Document 1: Response to the Applicant's Submission by William David Moore

I have submitted two documents in response to the [Applicant's Response to Deadline 8 Submissions](#). This is the first of those documents.

Document 2: Response to the Applicant's Submission by William David Moore

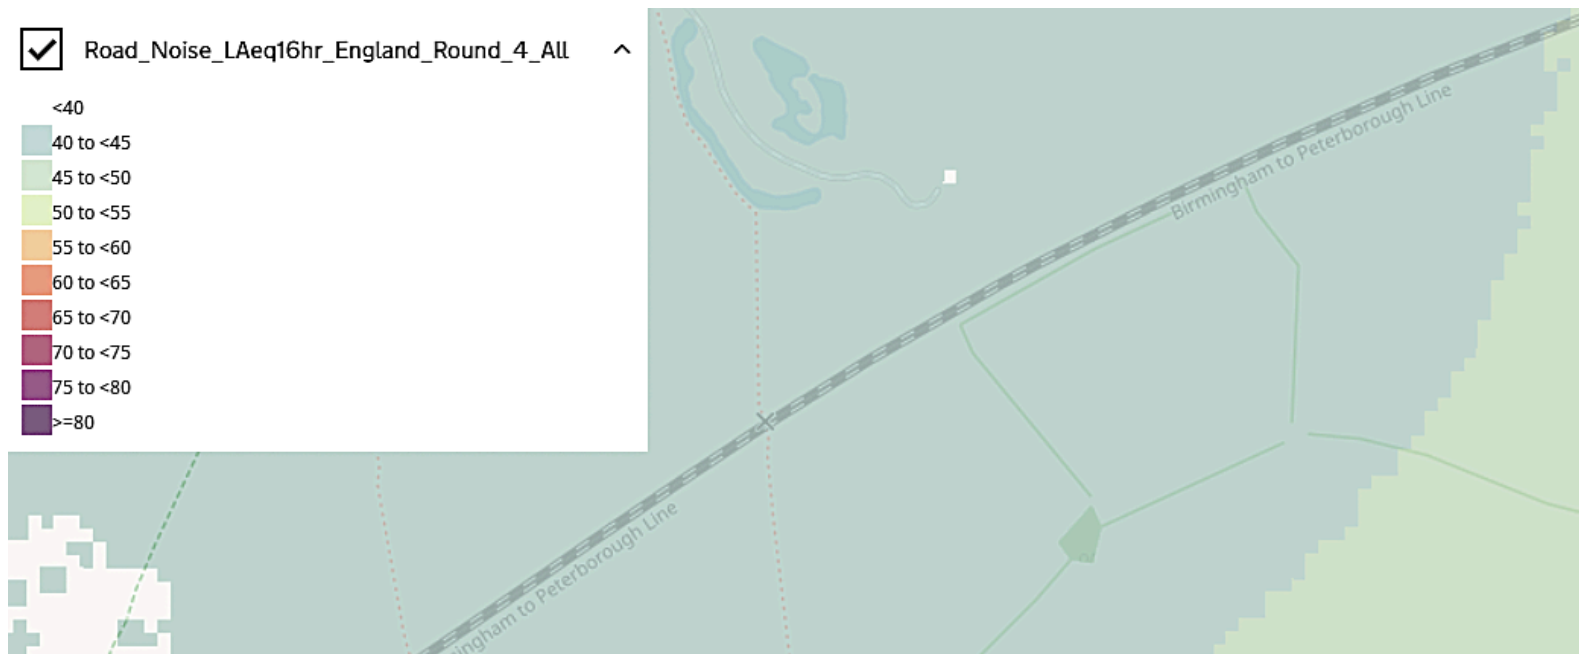
According to the applicant's road contours, the location experiences 55 dB of daytime ambient road noise due to the distant road noise.

The DEFRA Round 4 road noise contours show the location experiencing 40-45 dB of daytime ambient road noise. This is shown in the map below.

The DEFRA road contours match with the 39 dB weekday daytime background sound level determined by the applicant for NMP4. The applicant's contour claim doesn't match at all.

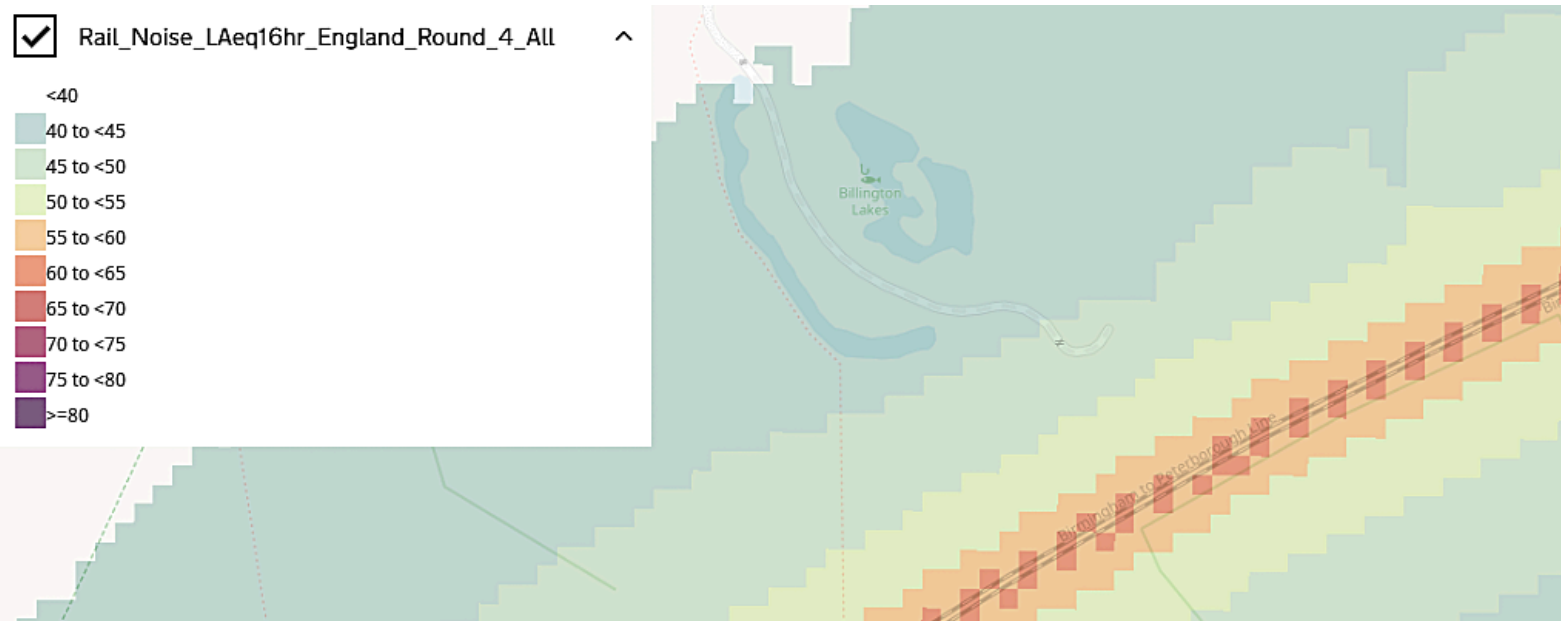
According to the contours introduced by the applicant, the location experiences 50 dB of daytime ambient rail noise.

The DEFRA Round 4 rail noise contours show the location experiencing 40-45 dB of daytime ambient rail noise. This is shown in the map below.

You can see the very high ambient rail noise which would be measured ~12 metres from the railway line. The applicant's NMP4 was located ~12 metres from the railway line. That's why it measured such high ambient sound levels.

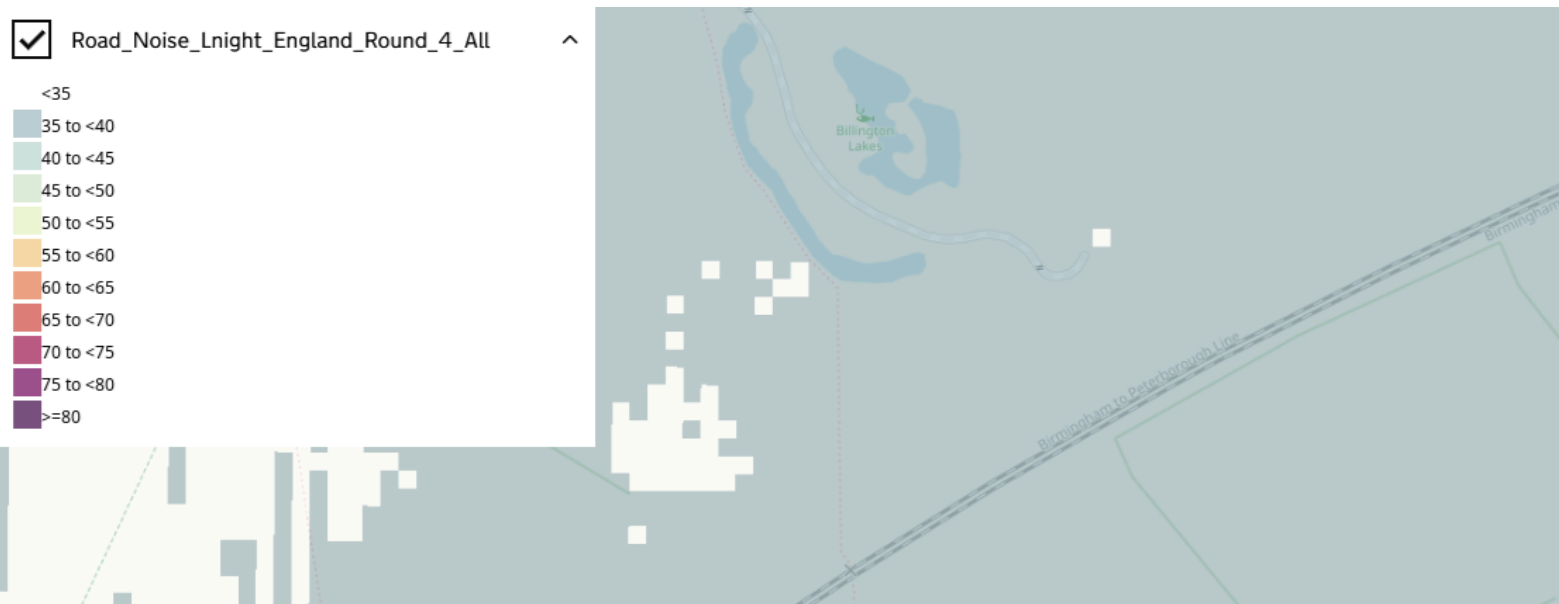
Table 3 shows the combined road and rail noise levels at the location for both the applicant's contours and the DEFRA Round 4 data. The measurements submitted at Deadline 8 are also shown.

The daytime measurements submitted at Deadline 8 are a close match with the daytime DEFRA contours.

Meanwhile, the applicant's contour claims are off in a world of their own, at odds with both the DEFRA contours and the measurements at the location submitted at Deadline 8.
